Russell Vale Colliery Underground Expansion Project

Second Review Report

March 2016

Figure 2. Existing and Proposed Upland Swamp Monitoring Network

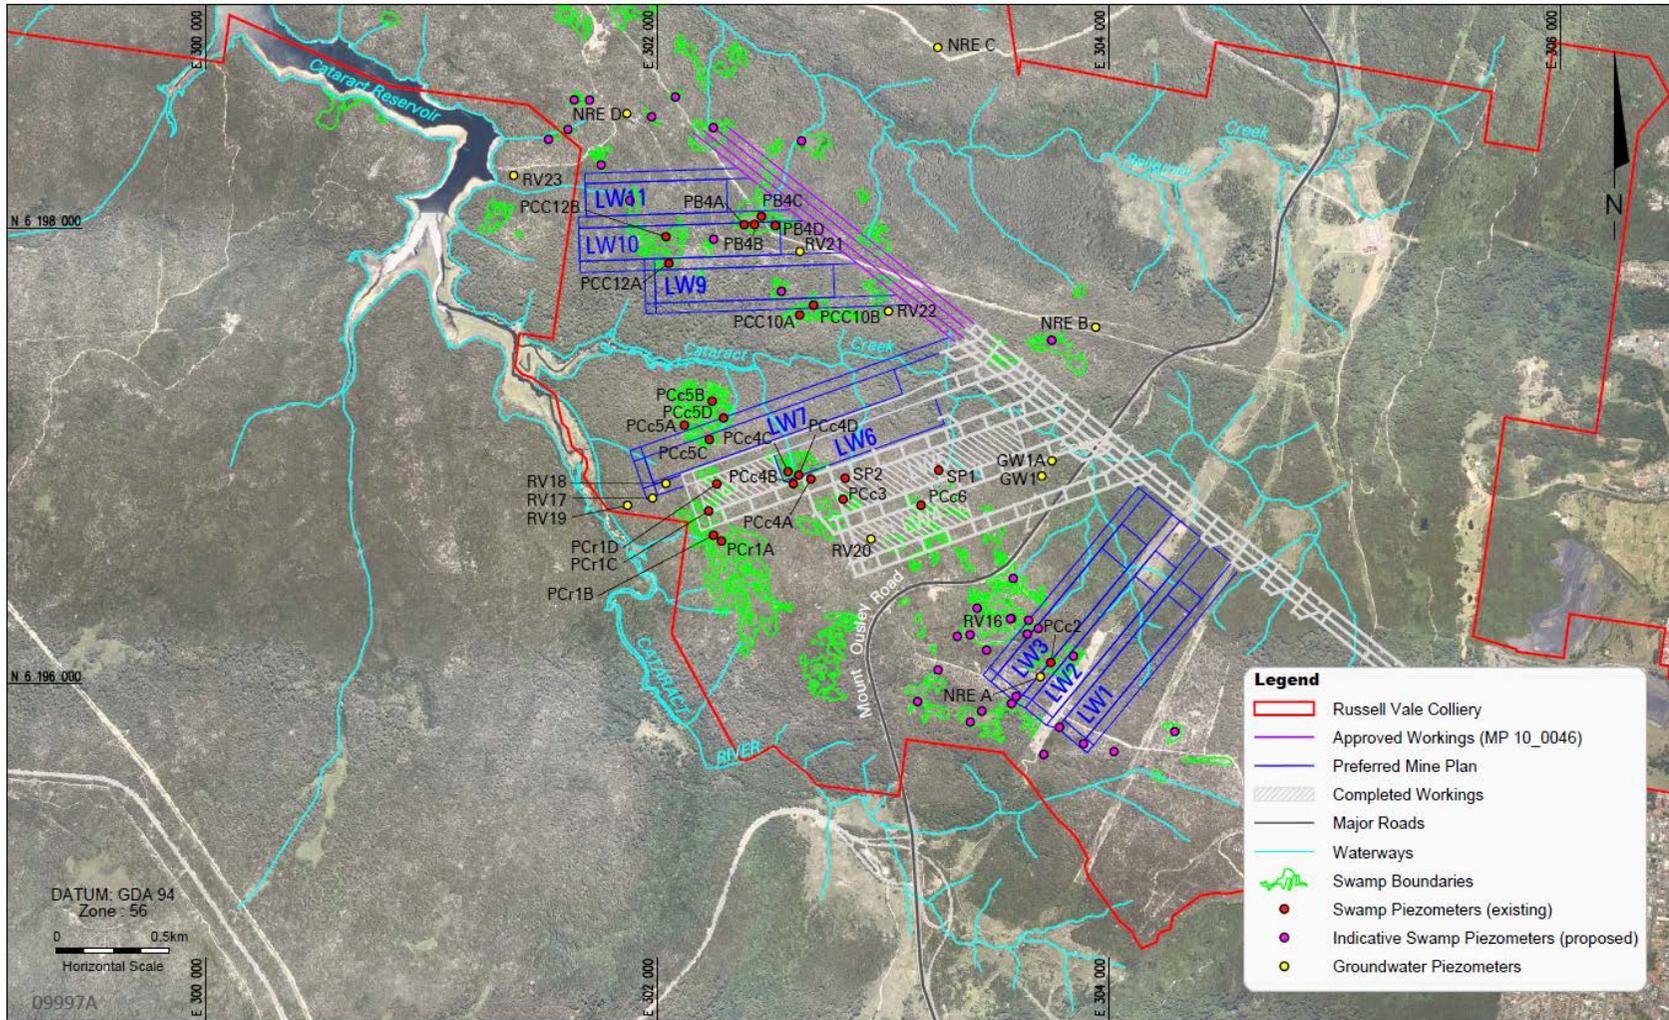
Figure 2 shows the existing and proposed upland swamps monitoring network¹⁸. Data from the piezometer network is being provided to the Integrated Risk Assessment Panel.

CCUS5 is predicted to experience a significant (26%) decline in overall water availability due to tilting associated with Longwall 7. Flow pathways within the swamp are predicted to change, possibly resulting in changes to vegetation composition in parts of the swamp.
